827-831 CONGRESS STREET

829 Congress Street

This office is unable to issue a fire escape for the above building because the plans are insufficient to determine compliance with BOCA Building Code.

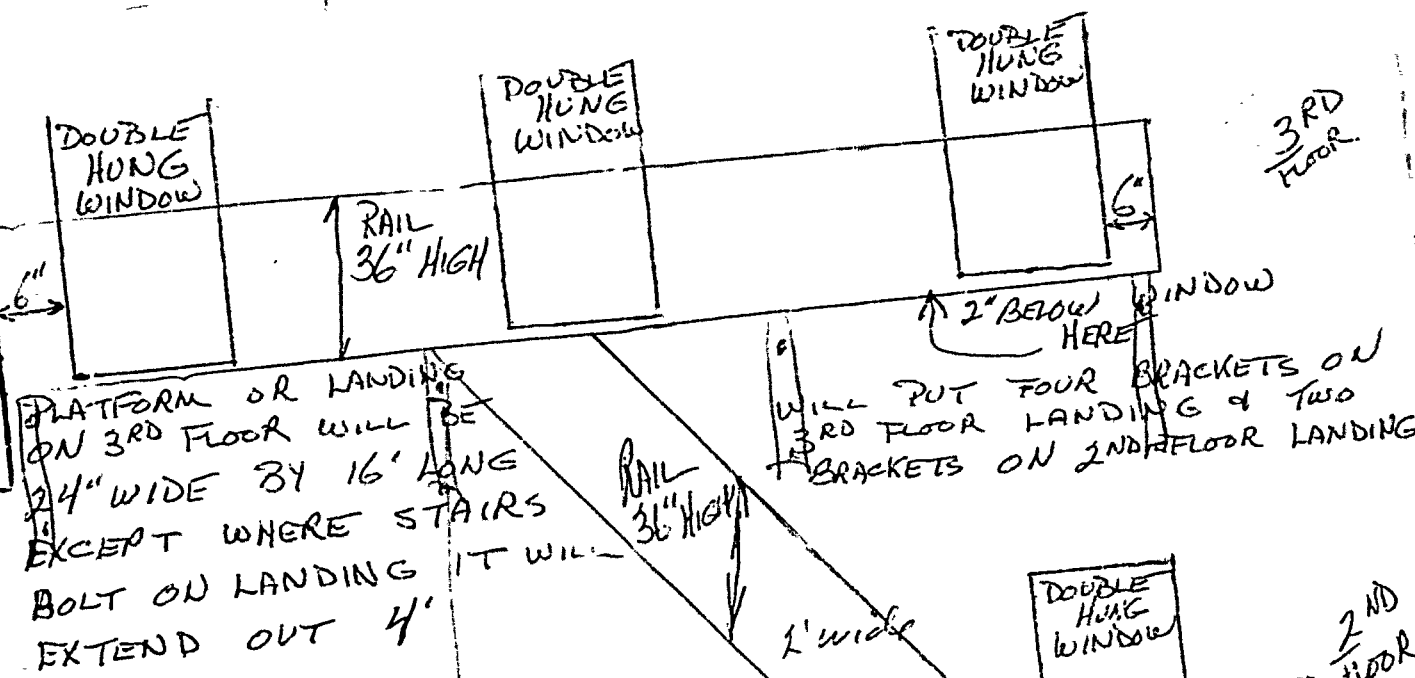
Please submit a sketch showing the rise and tread of the stairs, the size of material used in its construction, height of railings, how far the platform extends below the exit opening, how far it extends on either side of the exit opening, the size brackets which will be used to hold the fire escape in position, and whether or not you plan to have windows that swing out or double hung windows.

ALL MATERIAL USED IN FIRE ESCAPE
WILL BE $\frac{1}{4}$ " STEEL
BRACKETS WILL BE $2" \times 2" \times \frac{1}{4}"$ STEEL
& WILL BE BOLTED THROUGH WALLS WITH
 $\frac{3}{4}"$ BOLTS WITH STEEL PLATES INSIDE
HAND RAILS WILL BE $1\frac{1}{4}" \times 1\frac{1}{4}" \times \frac{1}{4}"$ ANGLE
STAIRS WILL BE $24"$ WIDE WITH $7"$ STEP & A RISE OF $9"$

PLATFORM ON 2ND FLOOR WILL BE $4'$ WIDE BY $5'$ LONG
WILL EXTEND BEYOND WINDOW $16"$ ON EACH SIDE
DROP LADDER TO GROUND

WOOD FIRE ESCAPE

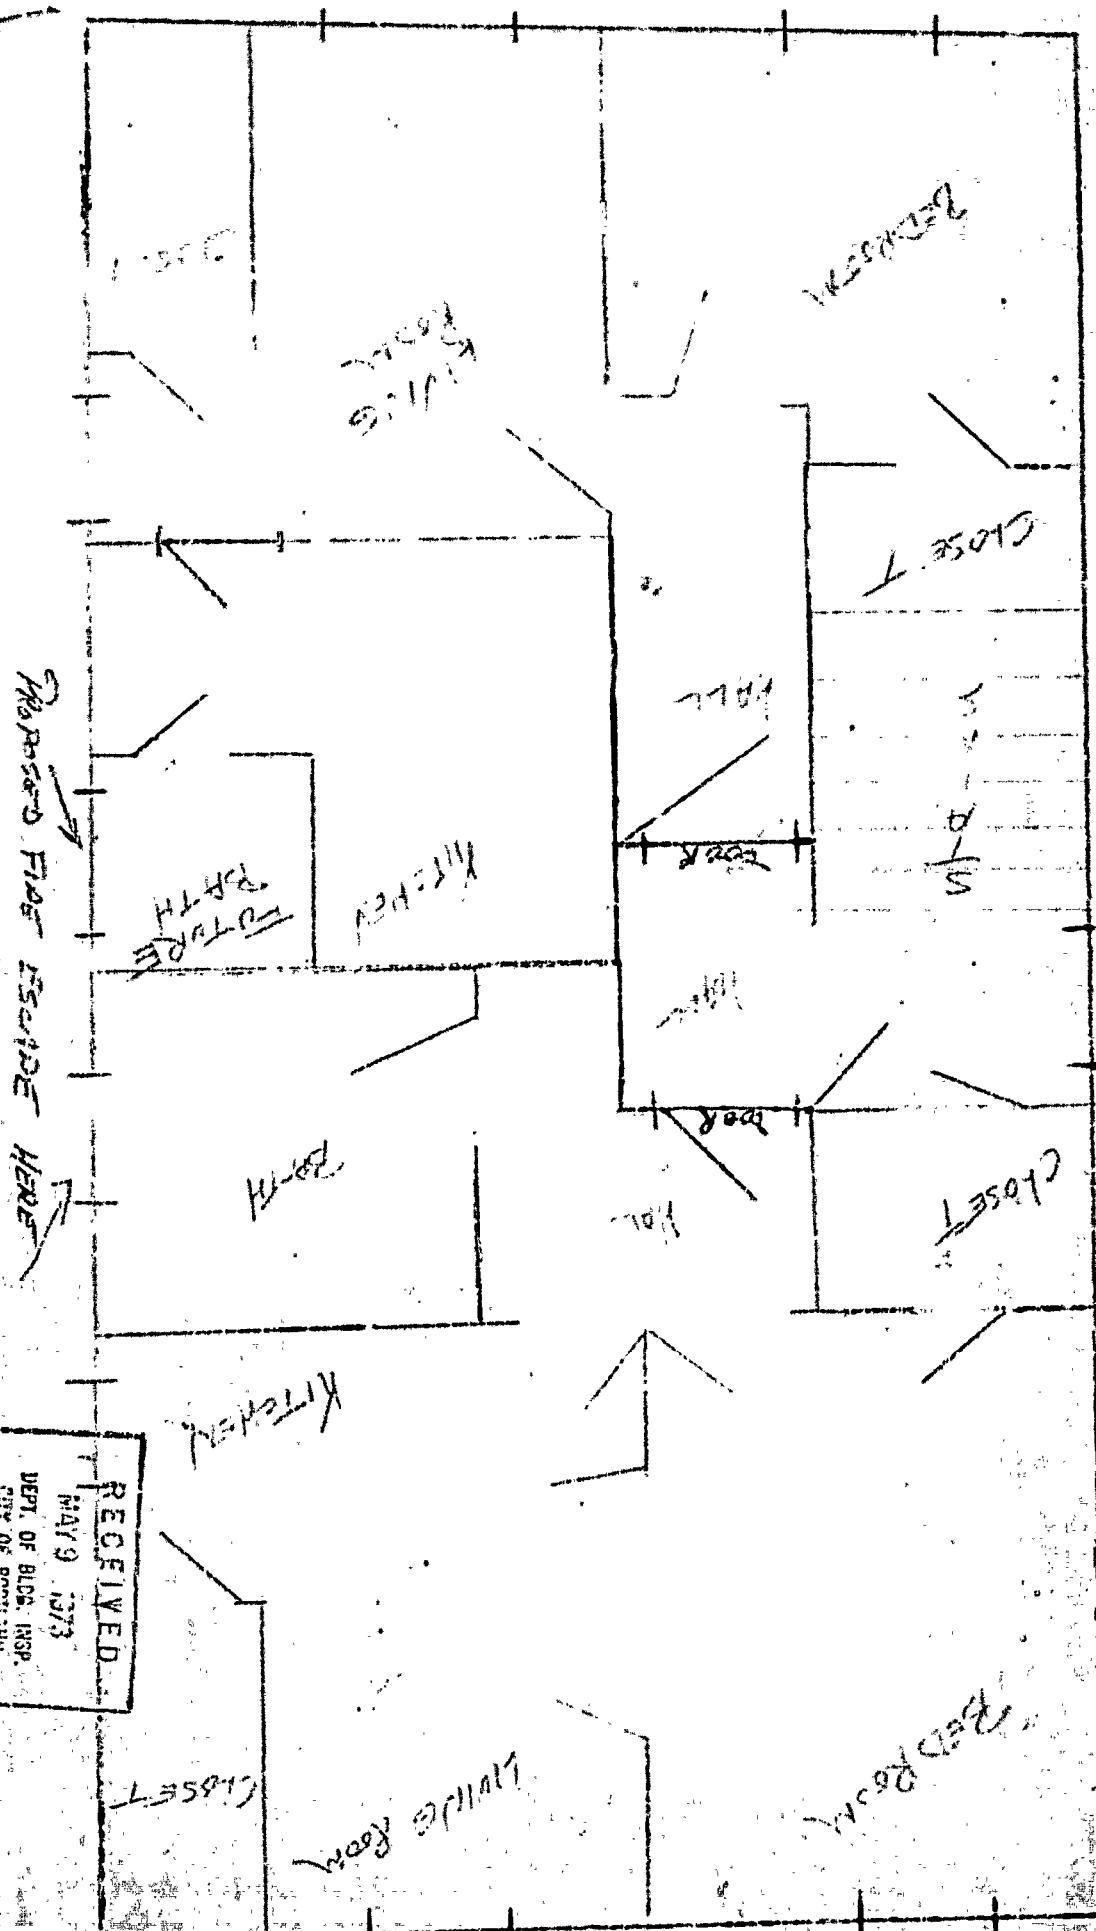
O In checking your application to change the use of this building at the above named location from four families to six, and to construct a fire escape from third floor to the second floor, we find that we are unable to continue processing your permit until further information is provided as follows:

1. You will need to show us windows for all rooms on the third floor that you have or that you propose to put in. You may come in and so indicate on the plan that you have here.

P 2. On this same plan indicate the location where the proposed fire escape will go.

3. We will need more information on wooden fire escape that you propose. We will need a plan that will show the framing, railing, stairway run (how it will be anchored to the building), etc. This will need to be done in detail so that we can check this against Building Code requirements.

THERE WILL BE
3 SUPPORT
BRACKETS ON TOP
PLATFORM & 2
SUPPORT BRACKETS
ON THE 2 OTHER
PLATFORMS

PLATFORM TO RUN ON BEHIND
WINDOWS ON EACH END NOT MORE THAN
18" BELOW THE SIDE
OF WINDOWS

PLATFORM WITH WILL
BE 4' WIDE & STAIRS WILL
BE 24" WIDE -
RAILINGS AND
STAIRS WILL BE
34" HIGH - RAILS
ON PLATFORMS
WILL 34" HIGH
SUPPORT BRACKET BOLTS
PASS THROUGH THE WALL
BUT 3/4" BOLTS &

PLATFORMS &
STAIRS WILL HAVE
NON SLIP SURFACE

PILE OF STAIRS
WILL BE VERTICAL
TO 8' HORIZONTAL
